Existing Use: UN DEVELOPED LOT
 Proposed Use: RESIDENTIAL HOUSE
 Estimated Construction Cost: \$ 508,700
 Description of Work: HOUSE BUILD CAR
4 Bedroom 2 1/2 Bath 3-Garage
Partial Finished Basement
 Occupant/Tenant Name: _____
 Was tenant space previously occupied? Yes No
 Contact Name: _____
 Address: _____
 City: _____ State: _____ Zip Code: _____
 Phone: _____ Fax: _____
 Email: _____

From: Oswald, Hank
Sent: Wednesday, July 26, 2017 9:26 AM
To: 'MIKE_BIRNER@HUNTSENDREMODELING.COM'
Subject: B17002571_17741 Hardy Road_Floor Plan Inquiry

RE: Woodcamp Lot 25
17741 Hardy Road

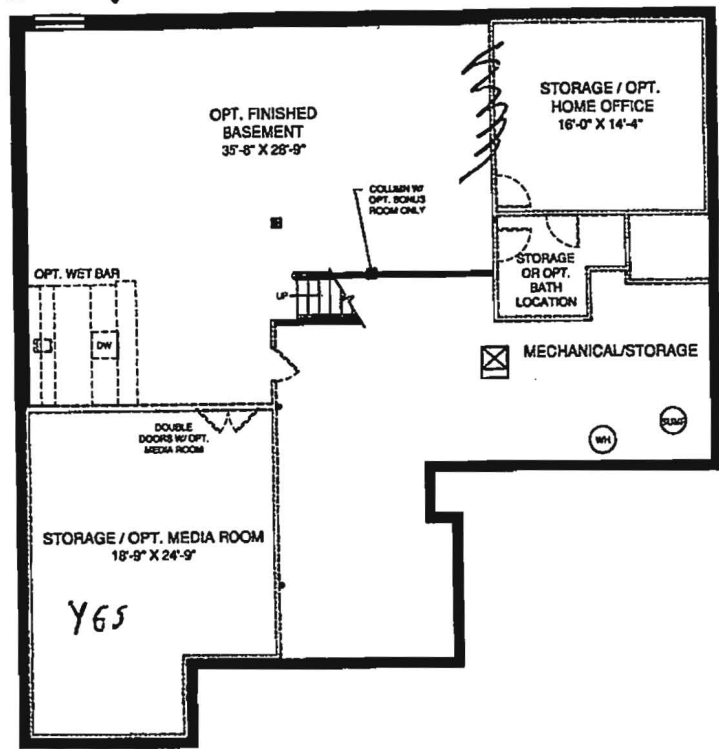
Good morning. I received a call from John P. who wanted to know about the status of the building permit for 17741 Hardy Road. I tried returned his phone call and left a brief message. At this point, we still need a revised OSDS plan showing the tank meeting the 20 foot setback to the house foundation. Also, there is a potential for a future bedroom in the basement so it might prove useful to size the septic system for 5 bedrooms (instead of 4). Lastly, I informed Mike awhile back that if the wall check included the covered porch as part of the foundation outline, we would not be able to issue the septic permit because the well box does not meet the 30 foot setback (I was looking for confirmation from him on this part of the project).

Anyway, as soon as we have the revised OSDS plan and issued the basement bedroom memo, we should be able to approve the BP. Should you have any questions, please don't hesitate to ask.

1. The septic tank location has been revised to be 20-feet from the house.
2. The home owner will be eliminating a wall in the basement to eliminate a future bedroom in the basement. Therefore, the septic system remains a 4-bedroom system.
3. The covered porch will be on footers and will not be part of the wall check.
